Jim
32 Parkside
Bedhampton

title: Proposed elevations

job: 1013 dwg: 1301 rev: A

EAST ELEVATION
1:50

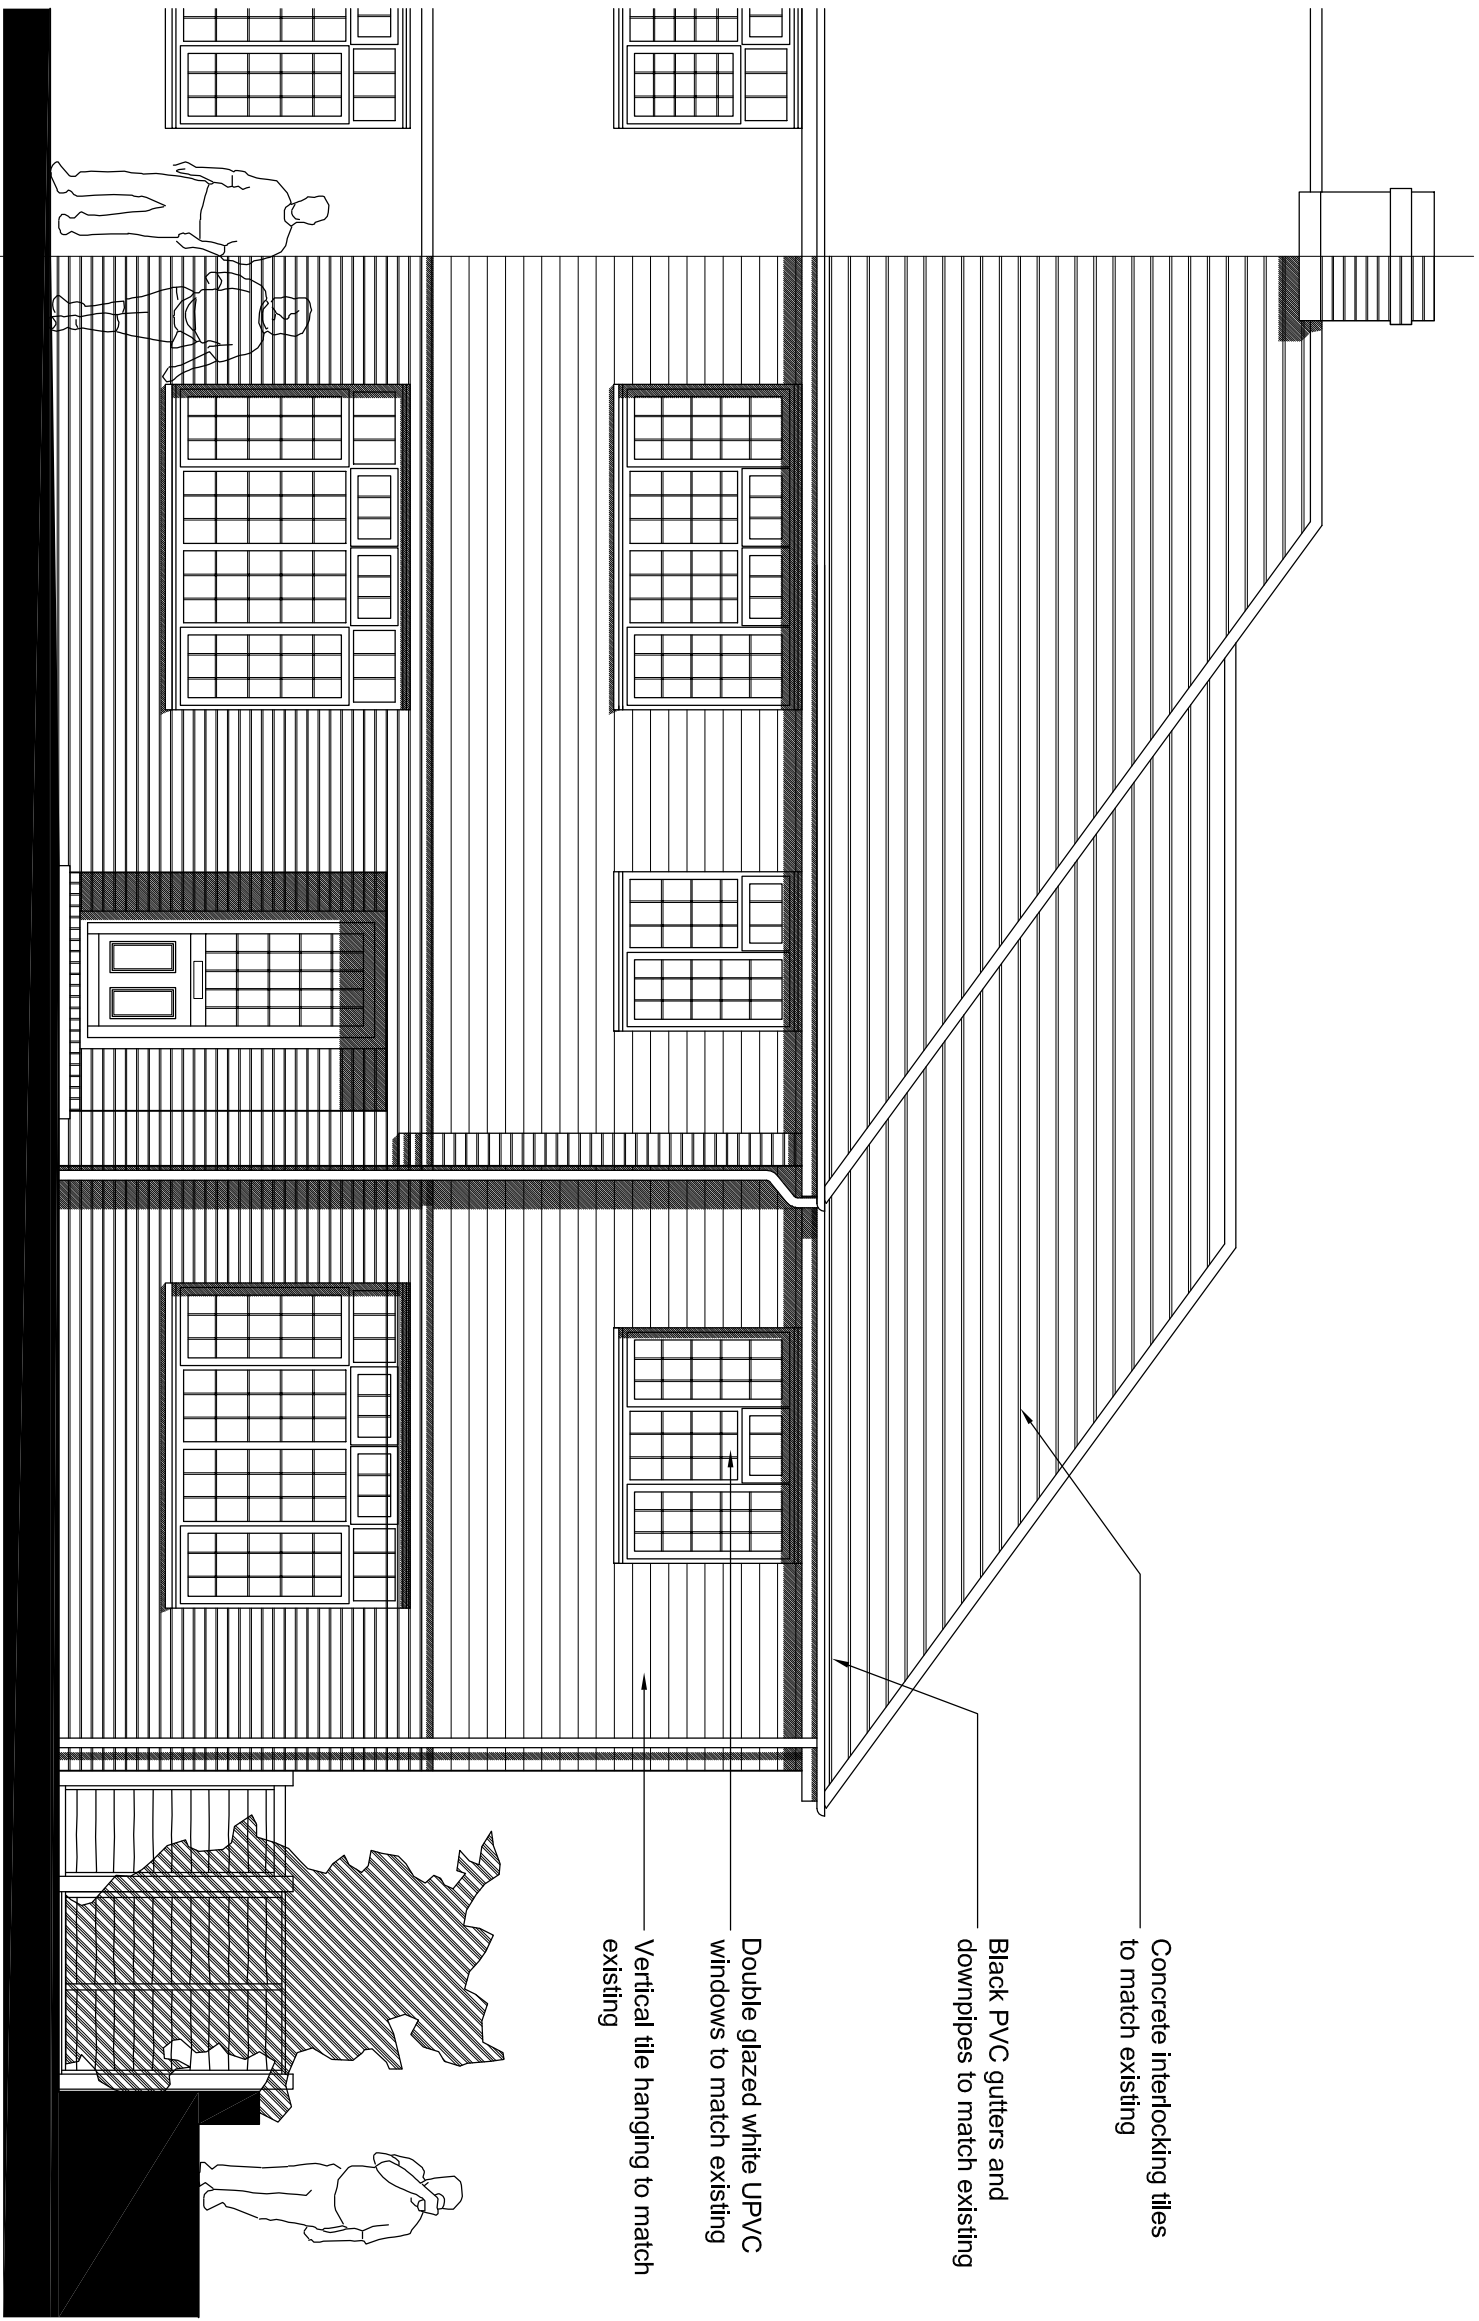
A. 11.12.16 . Timber cladding omitted and tile hanging added to East elevation
